STATE OF NORTH CAROLINA
DEPARTMENT OF TRANSPORTATION

Subject: Revised Application for Individual Section 404 and 401 Permits and Neuse Riparian Buffer Authorization for the construction of the southern section of Crescent Road from US 70 to US 258 in Lenoir County, west of Kinston. State Project No. 8.2200101. Federal Aid Project Number STP-224(3). TIP No. R-2719A., WBS 34501.1.1.

The purpose of this letter is to provide a revision to the application for a Section 404 Individual Permit, Section 401 Water Quality Certification, and Neuse Riparian Buffer Authorization. In addition to the cover letter this application package includes the following: revised permit drawings, a set of revised half size roadway plans, and a revised mitigation plan.

PLAN VIEW
 SITE 16

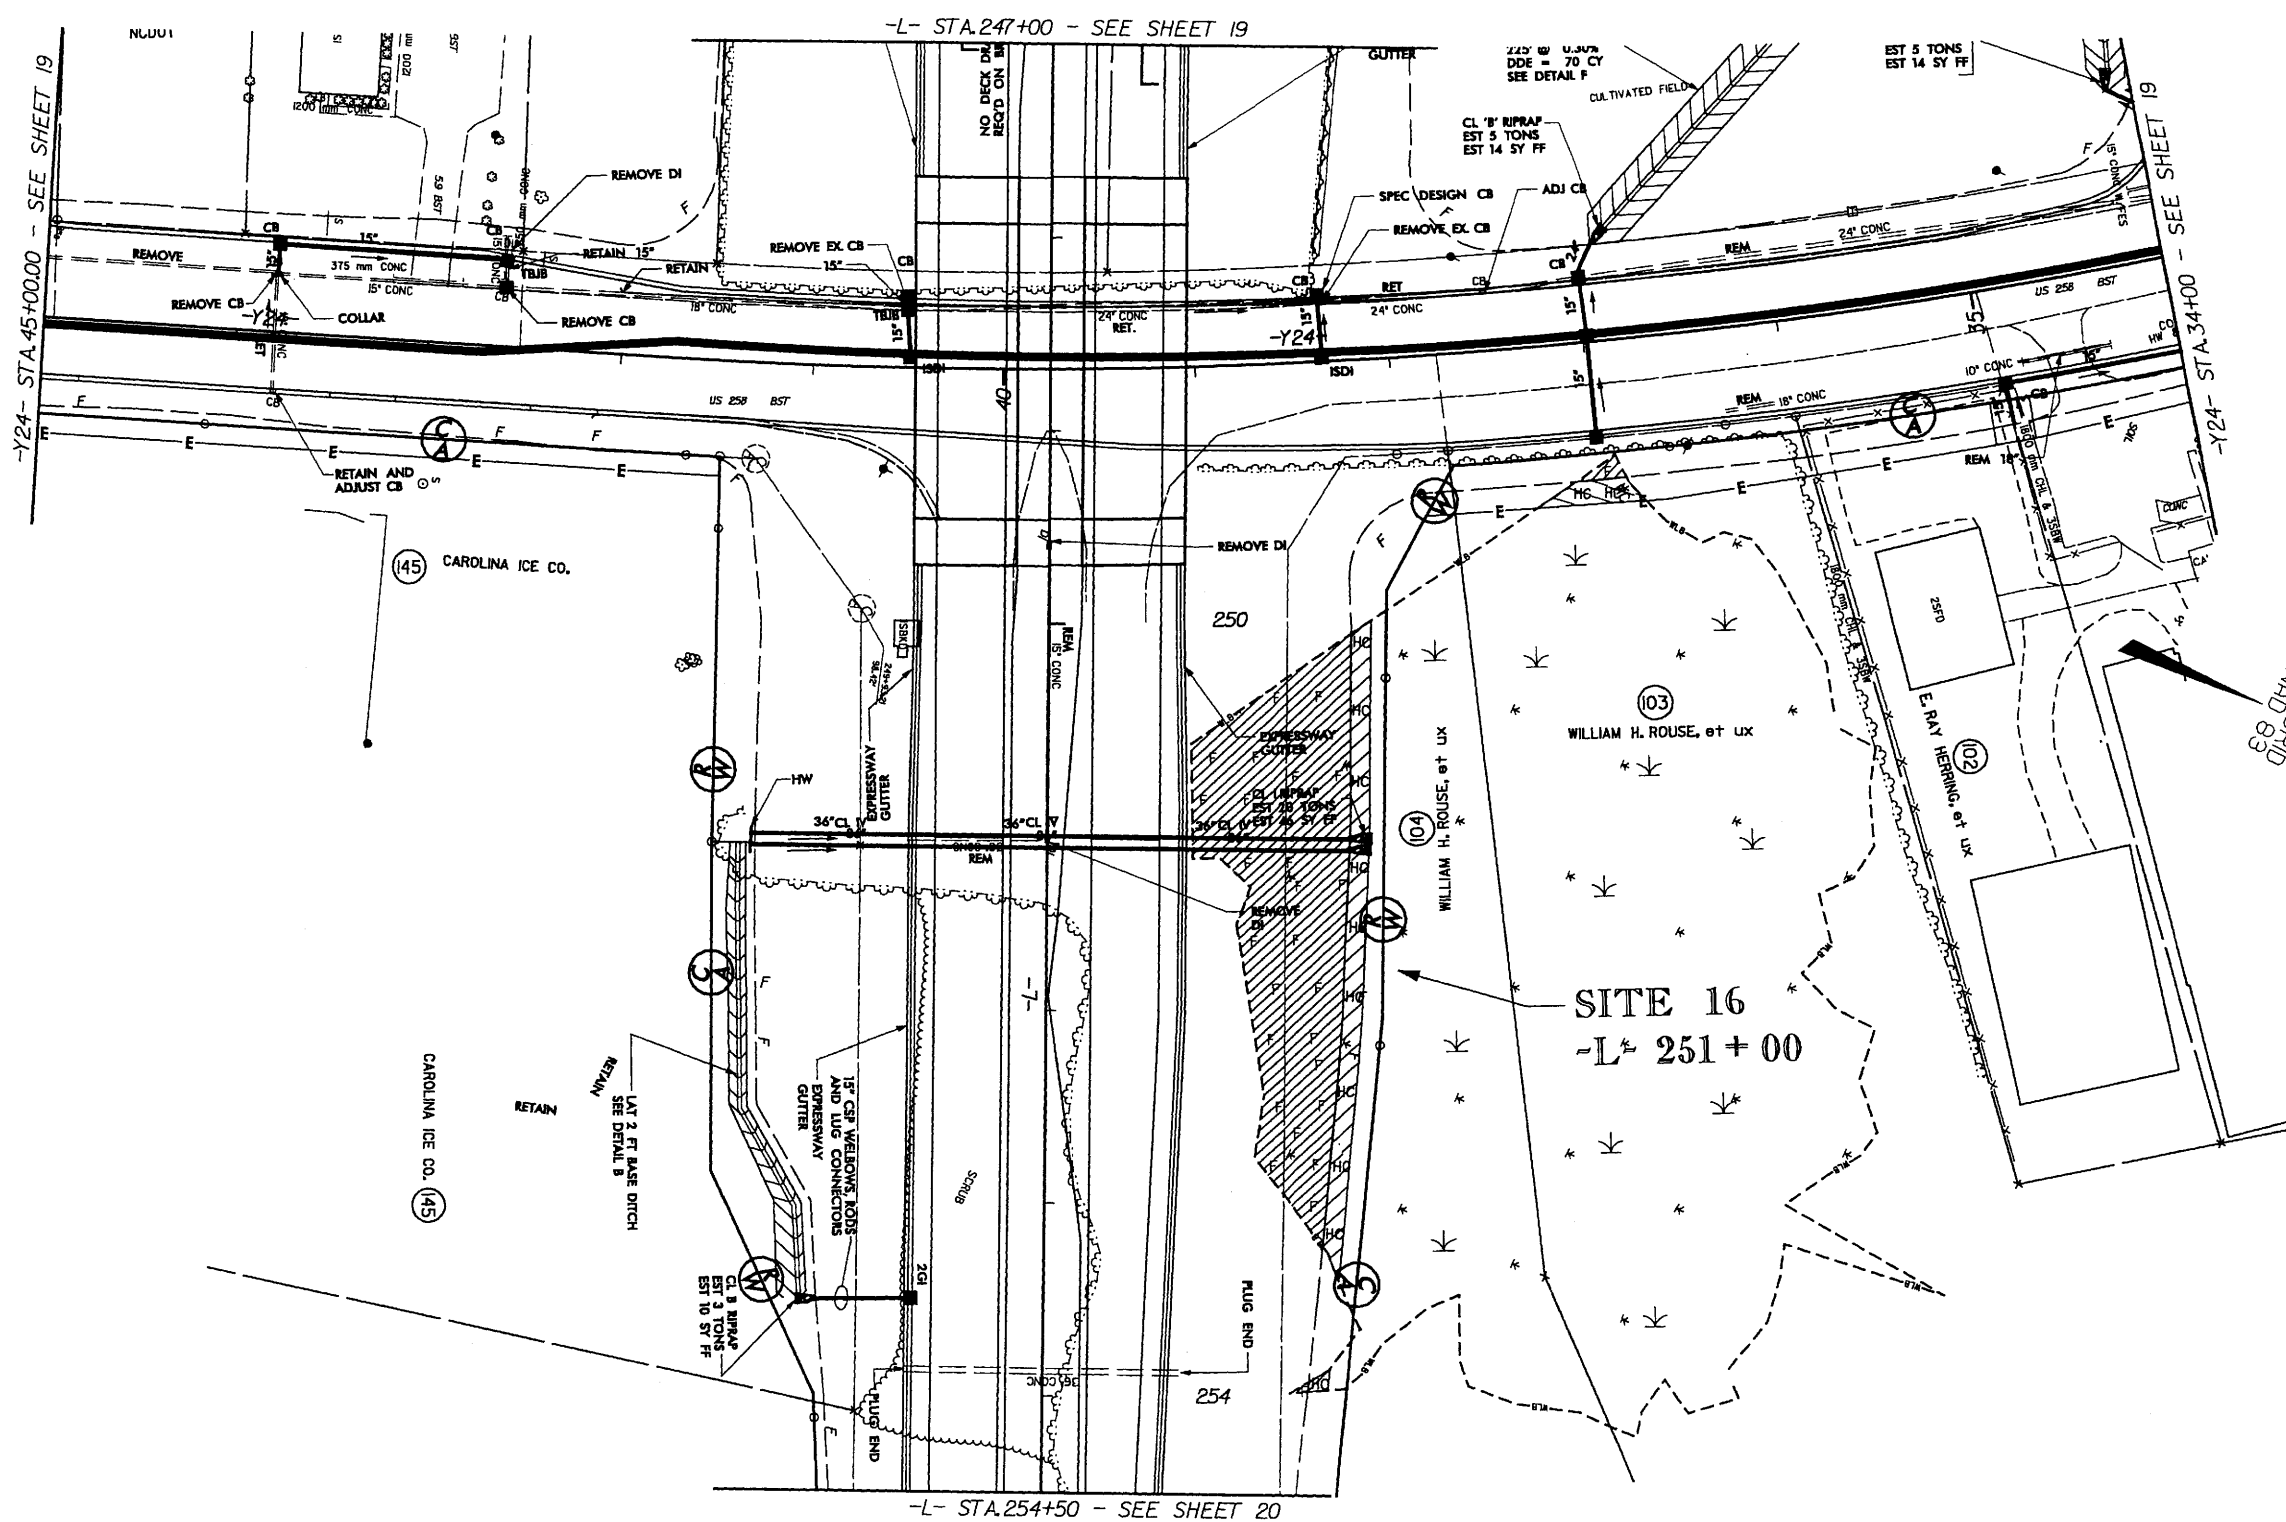
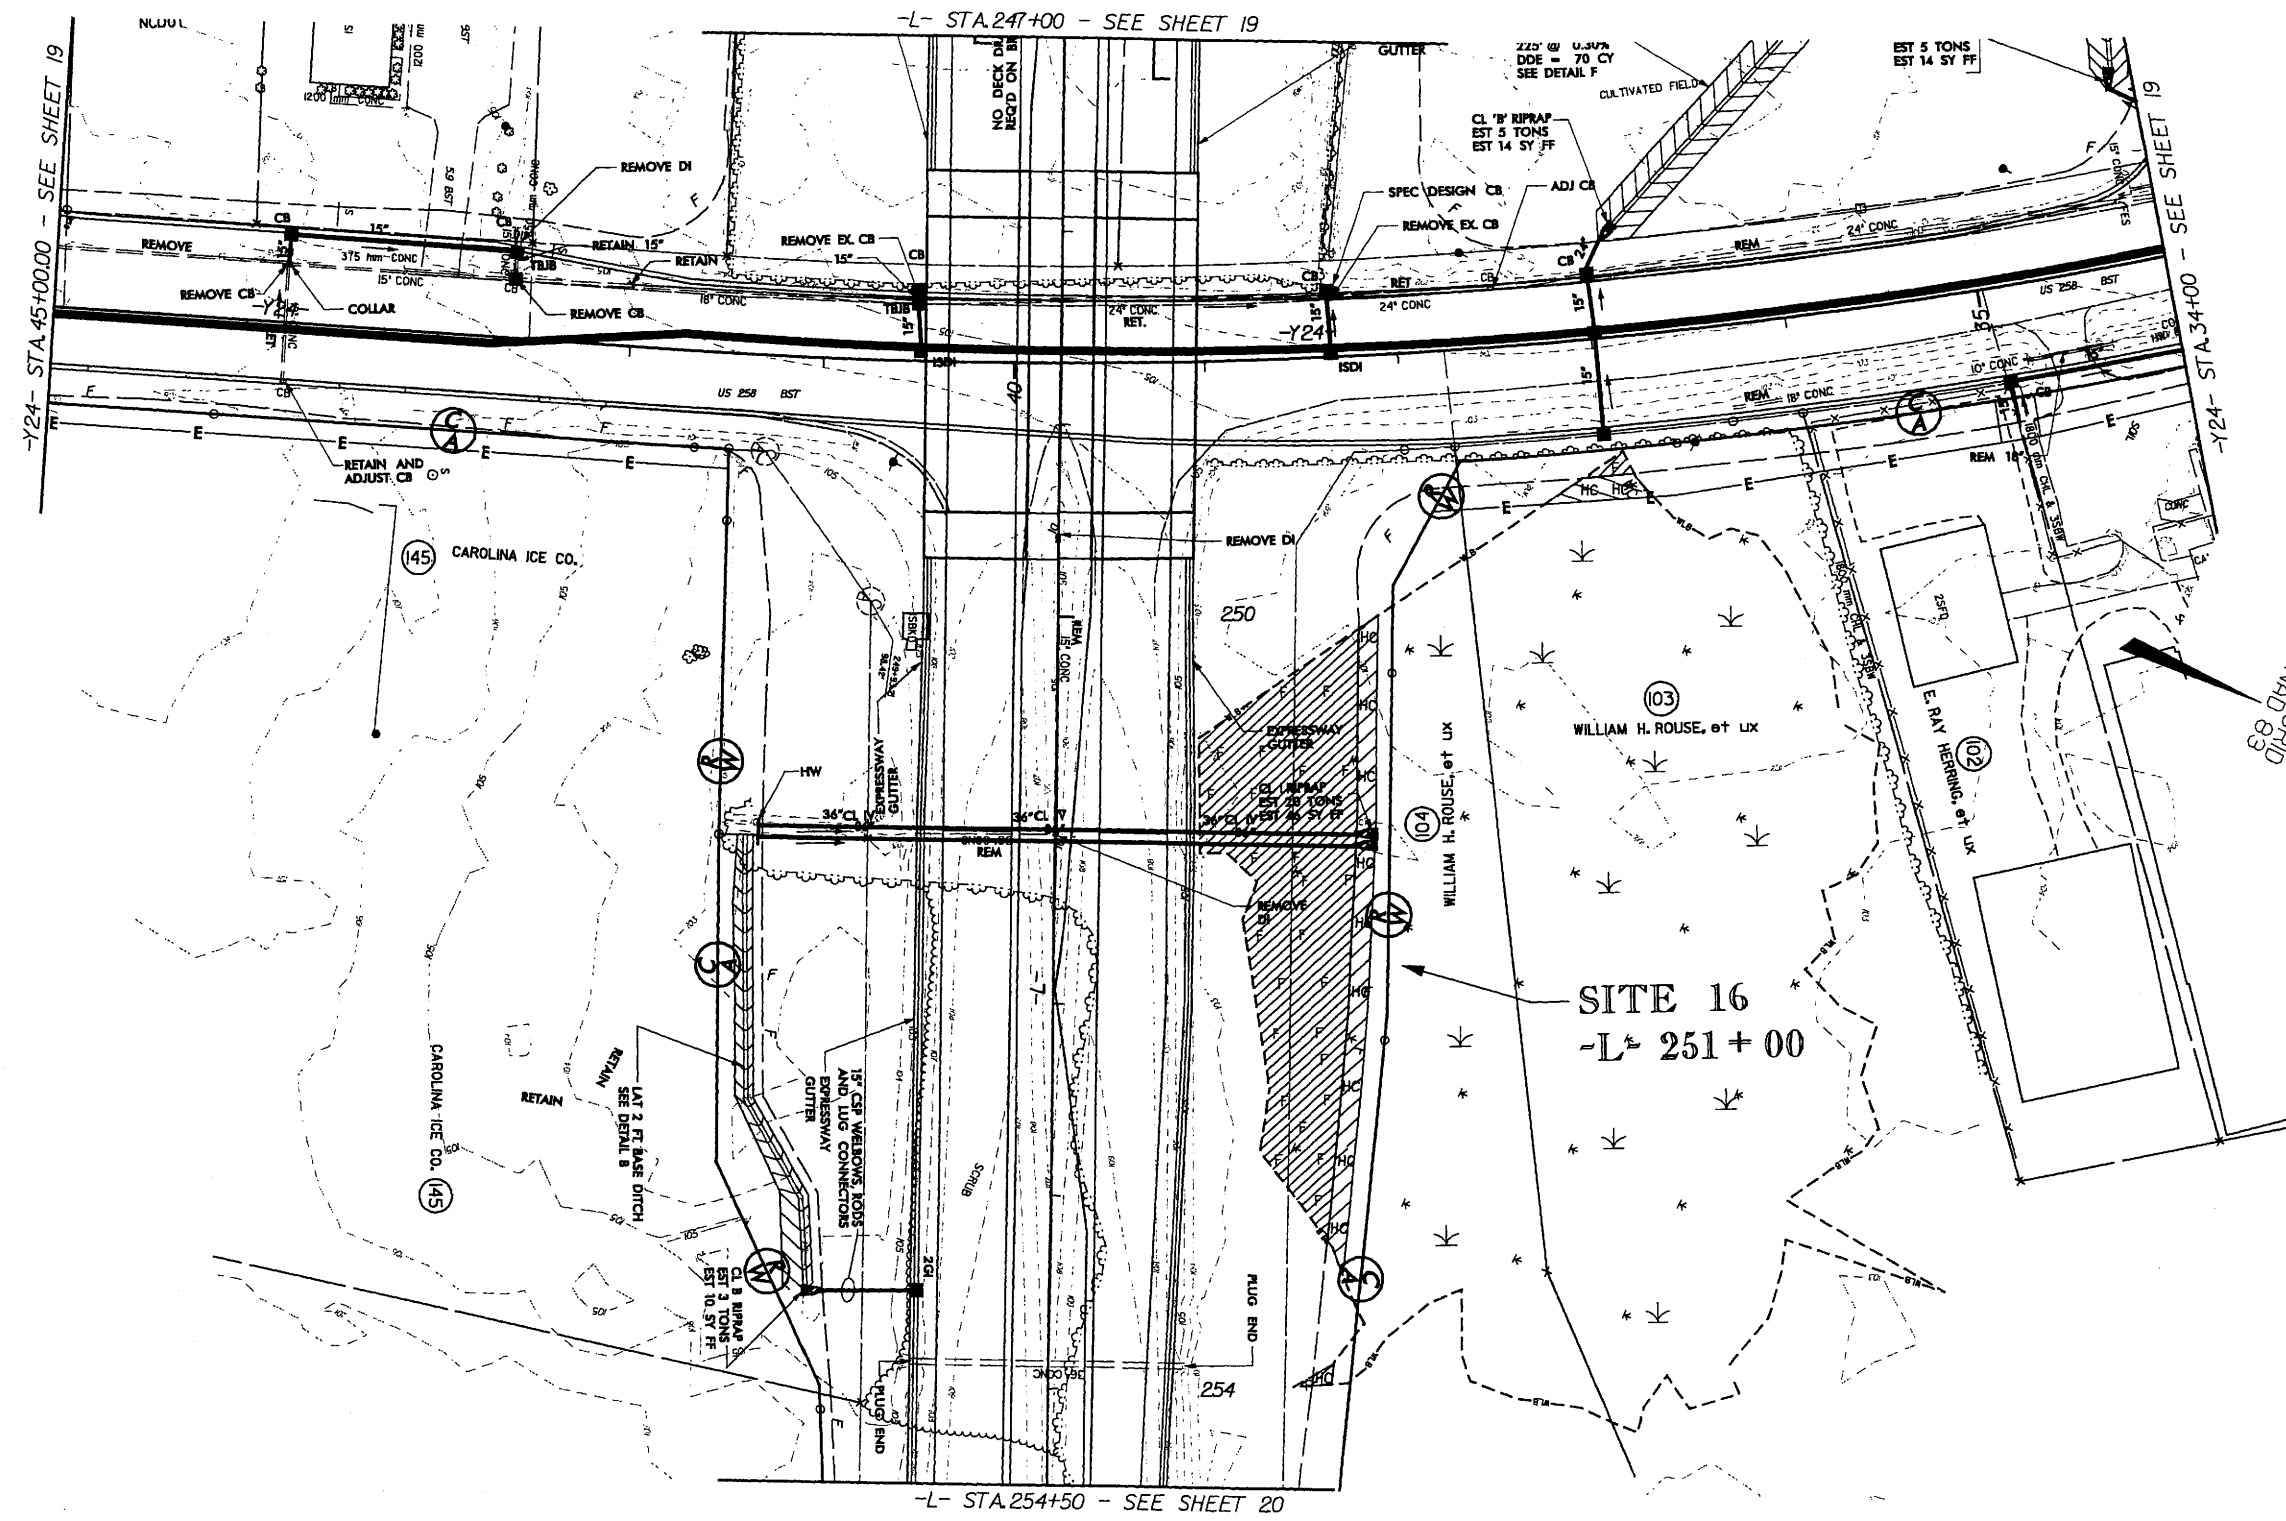
This revision describes the changes in the wetlands impacts due to the outcome of the reverification of the wetlands; also to describe the design change at the railroad crossing. NCDOT redelineated wetlands, due to the expiration of the jurisdictional determination. Several of the wetland lines were shifted as a result of this redelineation. Permit sites 8, 9, 10, 14, and 16 were changed and were verified by William Wescott with the USACE on March 6, 2008.
